Docket Number:	25-OPT-02
Project Title:	Prairie Song Reliability Project
TN #:	268943
Document Title:	Save Our Rural Town Comments - Scoping Comment Attachments 6-13 submitted by Save Our Rural Town
Description:	N/A
Filer:	System
Organization:	Save Our Rural Town
Submitter Role:	Public
Submission Date:	3/4/2026 4:37:56 PM
Docketed Date:	3/4/2026

Scoping Comment Attachments 6-13 submitted by Save Our Rural Town

Save Our Rural Town (SORT) respectfully submits the following comments to the California Energy Commission (Commission) pursuant to the referenced licensing Application filed in Docket 25-OPT-02 for a proposed Battery Energy Storage System (BESS project or BESS development) in the rural community of Acton. The comments presented herein address deficiencies noted in the revised application submitted on October 15, and in particular, they focus on insufficiencies in the alternatives analysis (which is so narrowly constrained that it is inadequate for the purposes of the California Environmental Quality Act - CEQA) and in discussions pertaining to water resources and socioeconomic/net benefits impacts. Additionally, comments pertaining to emergency access concerns and the “Com

Figure 3. Map of Feasible Location Alternatives.

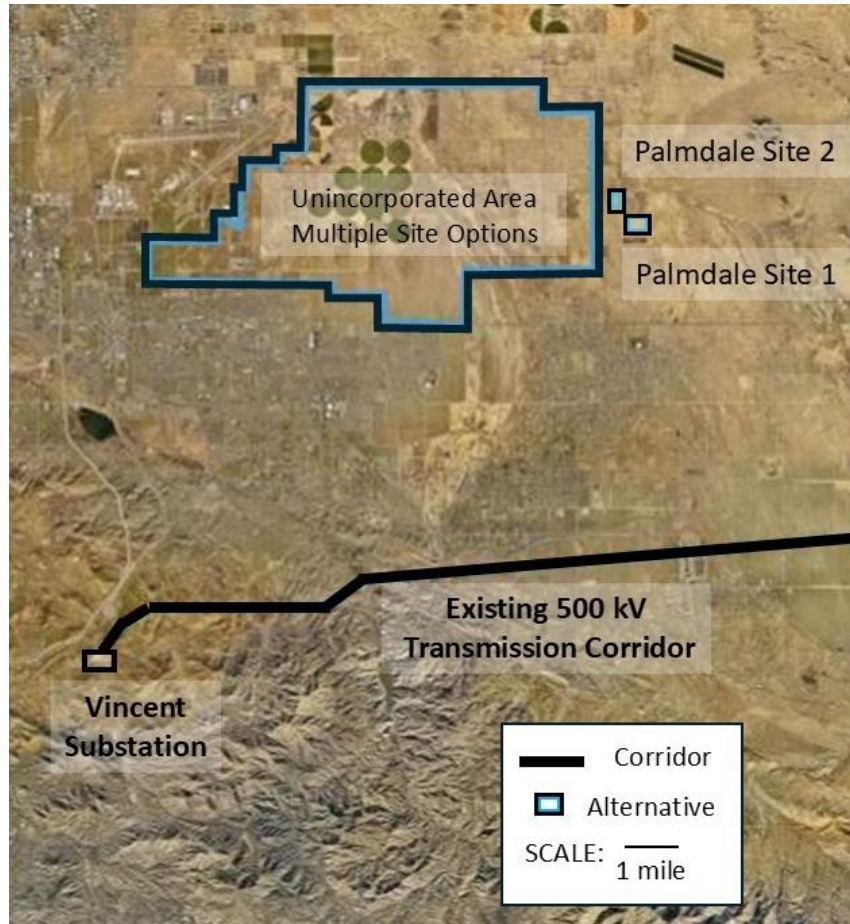
Alternative Location 2: The second alternative location that should be considered is a 26 square mile area in unincorporated East Antelope Valley that is designated for industrial purposes and where no residential uses are permitted. The area is depicted in Figure 3 and labeled as “Unincorporated Area”; it includes large tracts of vacant and irrigated lands that are adjacent to industrial uses and outside of mapped Significant Ecological Areas. These tracts are more than a mile from any residence, and since at least 1973, these lands have been designated as “Public and Semi Public lands” by the County General Plan. According to both the 1980 and the 2015 County General Plans, these tracts of land are “intended to be used for major utilities, transportation facilities, waste facilities, etc.” The tracts are owned by the City of Los Angeles and they lie adjacent to aerospace facilities and an airstrip owned by the US Government (known as Air Force Plant 42). Locating the BESS within one of these tracts of land would substantially lessen the significant noise, visual resource, and public safety impacts of the BESS Project; it would also substantially lessen all significant impacts stemming from land use conflicts. Because nearly all of these tracts lie outside of high and very high fire hazard severity zones, Alternative Location 2 substantially reduces the significant wildfire impacts posed by the BESS Project. Furthermore, a transmission interconnection can be easily accomplished because Alternative Location 2 it is just 6 miles north of an existing 500 kV transmission corridor that terminates at the Vincent substation. The corridor has multiple single circuit 500 kV lines and, on the north side, a 220 kV line. By expanding the corridor or (better yet) upgrading the 220 kV line to a

Figure 5: Details on Zoning and Land Uses for Alternative Locations 3 and 4.

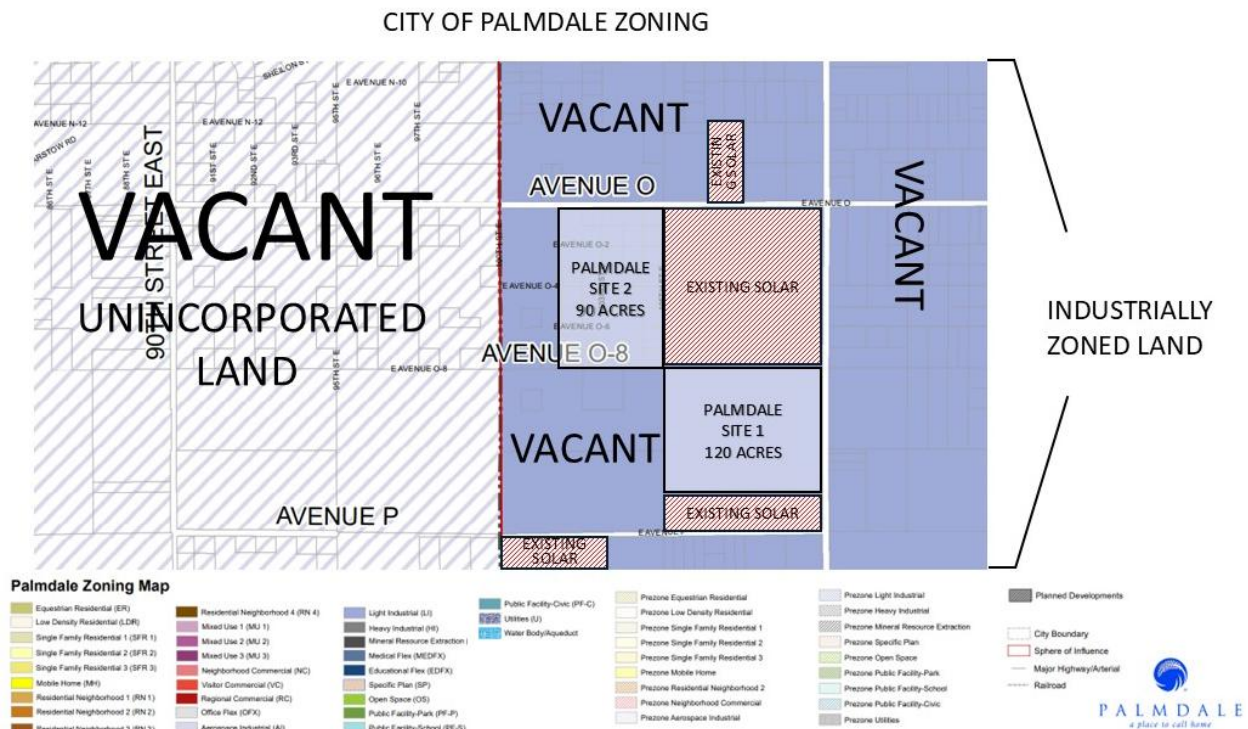
Other alternative locations in East Antelope Valley are in the City of Palmdale adjacent to the unincorporated “Public and Semi Public Lands” described above. These locations (depicted in Figure 3 as “Palmdale Site 1” and “Palmdale Site 2”) are north of the existing transmission corridor described above; thus, interconnection to the Vincent substation can be accomplished largely with corridor modifications and franchise agreements. The sites are sufficiently large to accommodate a 30 acre BESS yard and 23 acre substation and are outside of any mapped Significant Ecological Areas. While portions of these sites have small drainage courses, there is sufficient space available to avoid these areas. These properties are thousands of feet from any residential structures reported on County property tax rolls and they are not in “High” or “Very High” Fire Hazard Severity Zones. As indicated in Figure 5, these parcels are zoned for industrial use and are adjacent to extensive utility scale solar facilities. Some of these parcels may be owned by the City of Los Angeles; others are privately held. Given the zoning on these sites, their separation from residential areas, and their CalFire designation, these Alternative Locations will substantially lessen the significant environmental effects posed by the BESS Project.

Figure 6. Excerpt of Revised BESS Project Site Plan (Annotated in Red).

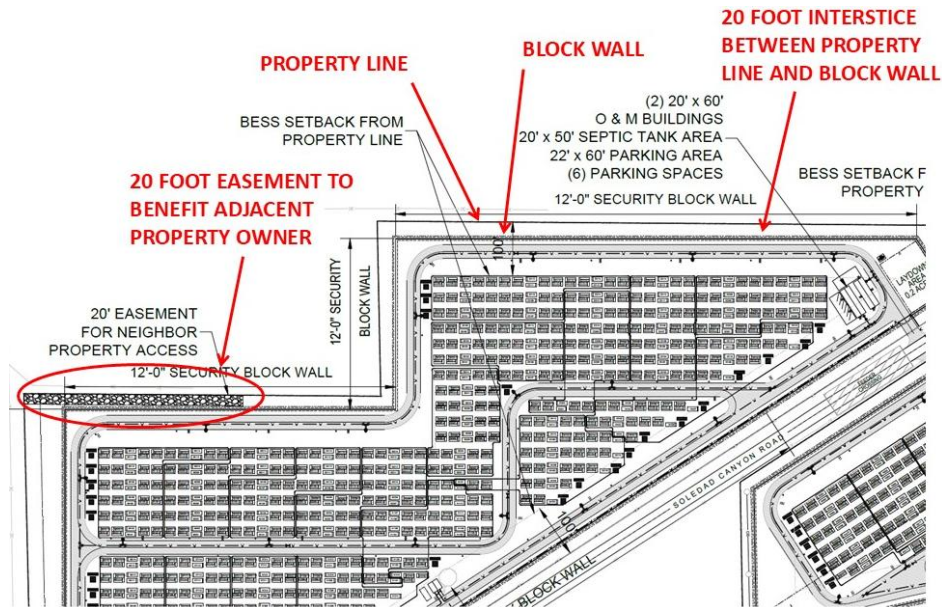
The revised Application does not appear to address concerns raised by SORT pertaining to emergency access²² and the fact that the BESS Project eliminates secondary access to adjacent residences. Recently, SORT learned that the primary access for adjacent residences is prone to erosion and is thus substandard; therefore, the BESS Project will eliminate the only reliable access route for Acton residents. This significantly adverse impact cannot be ignored, particularly since it can be easily mitigated. Specifically, the revised Site Plan²³ indicates that, along the northern wall surrounding the western the BESS yard, there is a 20 foot wide interstice between the property line and the block wall (see Figure 6). SORT presumes this interstitial area is intended for landscaping, but it could be configured and slightly widened to accommodate both landscaping and an access road that can be used by emergency vehicles and surrounding residents. The Applicant would provide an easement granting public access rights along, across, and over this access road. As Figure 6 shows, the developer proposes such an easement along the north wall to benefit one resident²⁴; this easement should be extended to benefit other residents and, for trail purposes, it should surround the entire development (which will mitigate the trail impacts that SORT previously identified²⁵).
